Walmart / Rio Bravo

FEASIBILITY DESIGN

REPLACEMENT CULVERTS

**ARENAL MAIN CANAL/RIO BRAVO BOULEVARD
CROSSING AT ISLETA DRAIN**

FIGURE 2

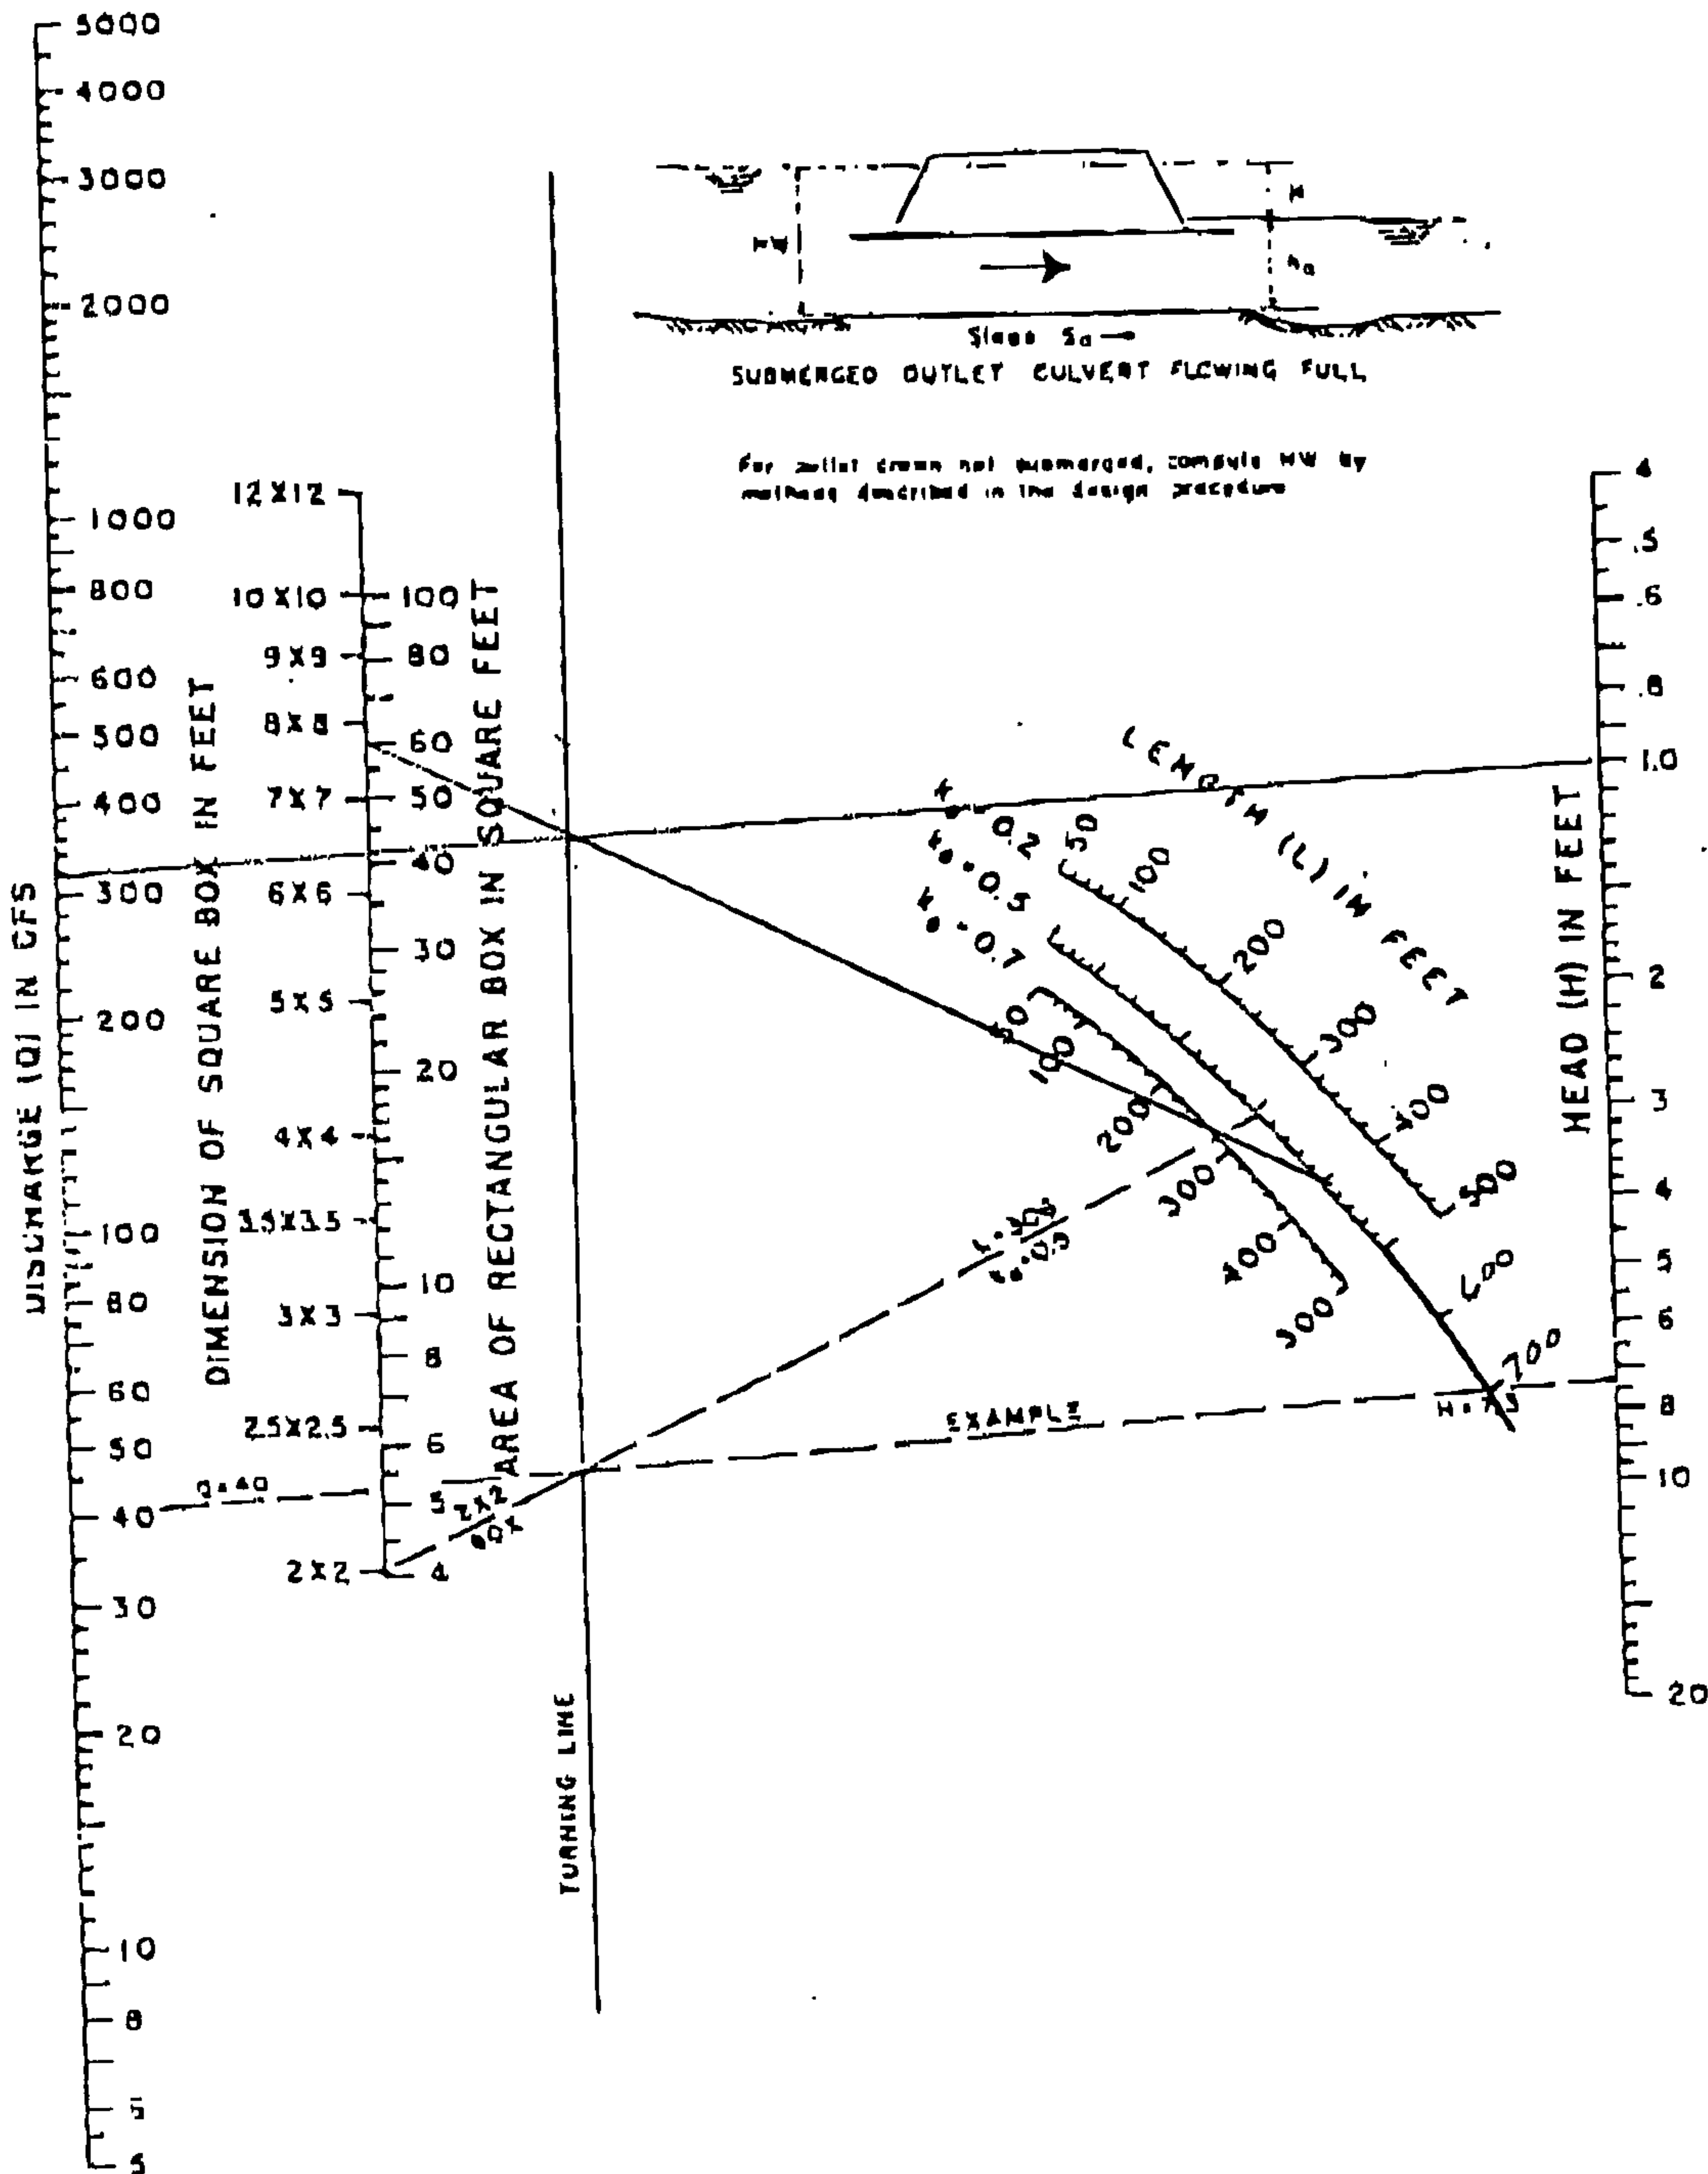
The recommended improvement to pass the design flow of 560 cfs was based upon the results of K-ROUTE modeling. A number of iterations were performed to determine the water surface elevations within the Isleta Drain and the optimum culverts to pass the required flow without overtopping the drain. The K-ROUTE model input includes a culvert outflow rating curve derived from the New Mexico State Highway and Transportation Department (NMSHTD) nomographs contained within "Drainage Manual-Volume II, Hydraulics, Sedimentation and Erosion." Initial iterations showed that the 6' high culvert outlet would be submerged. Therefore, Chart 15, page A-21 of Volume II, for concrete box culverts flowing full along with a submerged outlet was selected. Using 1-foot of differential head, based upon previous assumptions from the Southwest Valley study, Chart 15 indicated that a minimum of two 6'x10' box culverts would be required, and they will discharge 320 cfs per box, or a total of 640 cfs. See Figure 2.

FIGURE 3

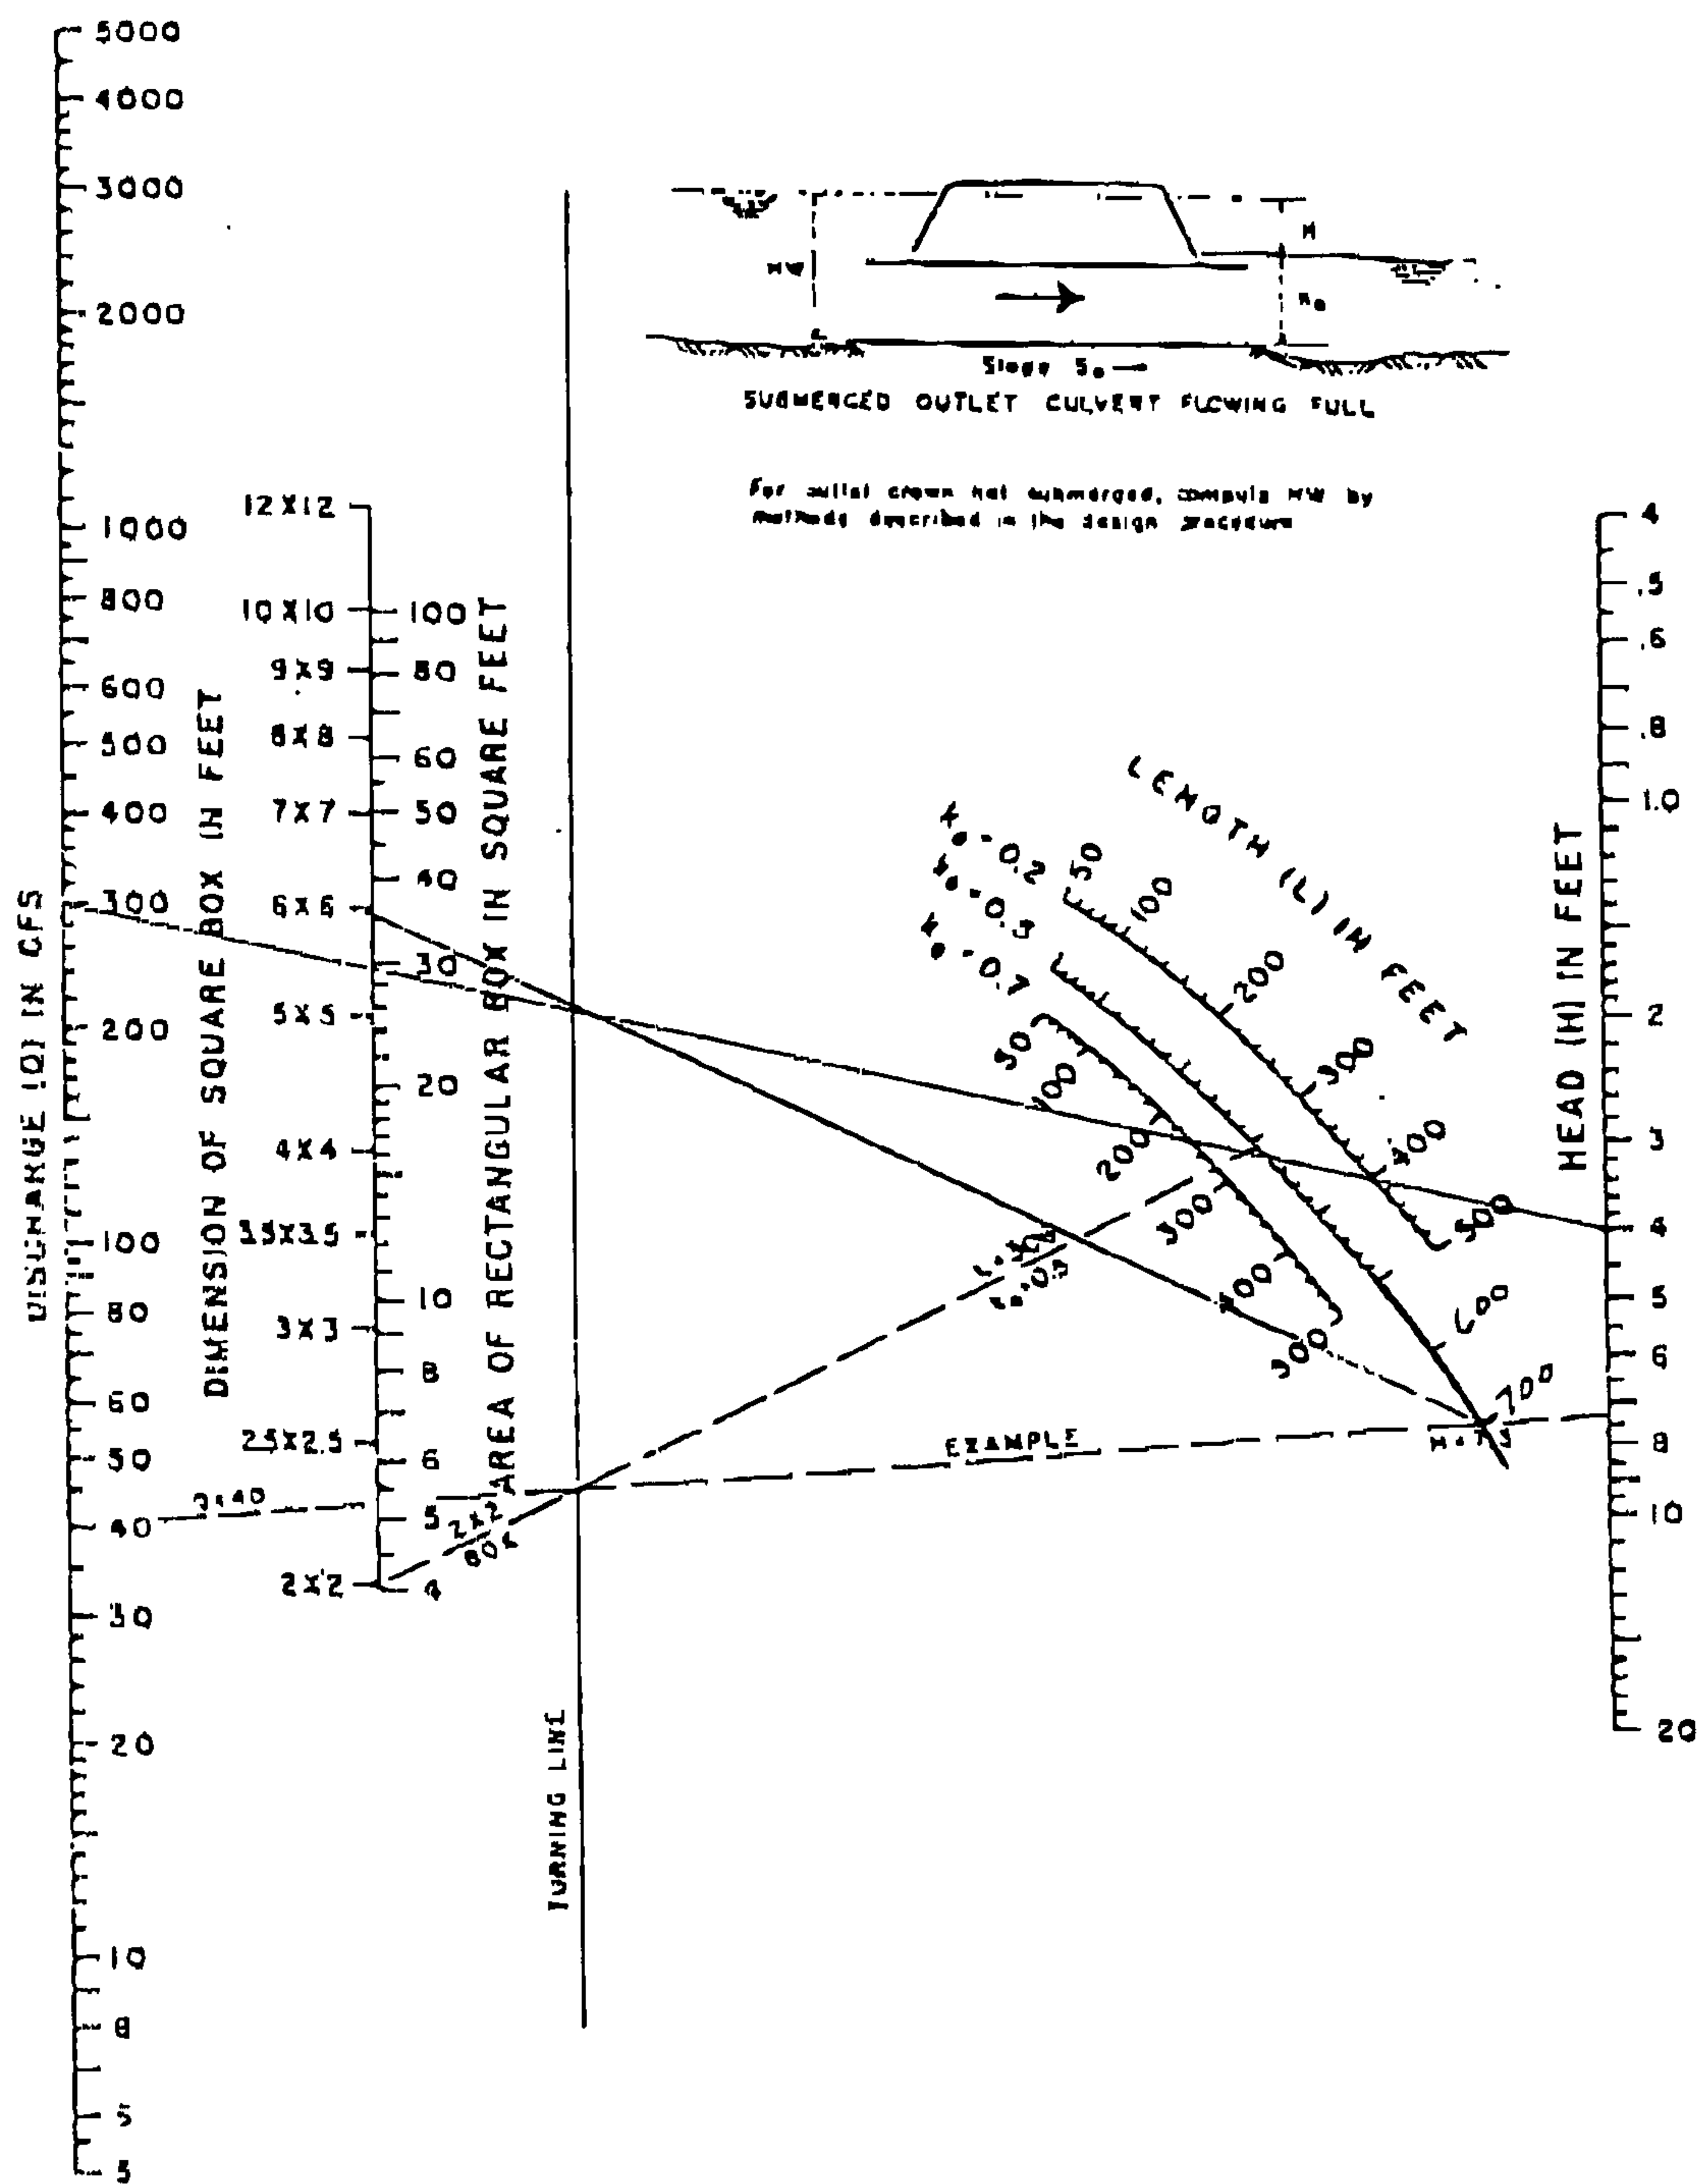
The Walmart site will replace the existing farm land with their buildings and parking facilities. This will eliminate the need for the lateral crossing that is currently serving this farming operation. Therefore, this portion of the Isleta Drain can be lowered from 4920 feet to 4916 feet, the existing drain bottom elevation downstream of the lateral crossing. This will increase the available differential head to 4 feet. Using 4 feet of differential head, Chart 15 indicated that two 6'x 6' box culverts would be sufficient, and they will discharge 300 cfs each, or a total of 600 cfs. See Figure 3.
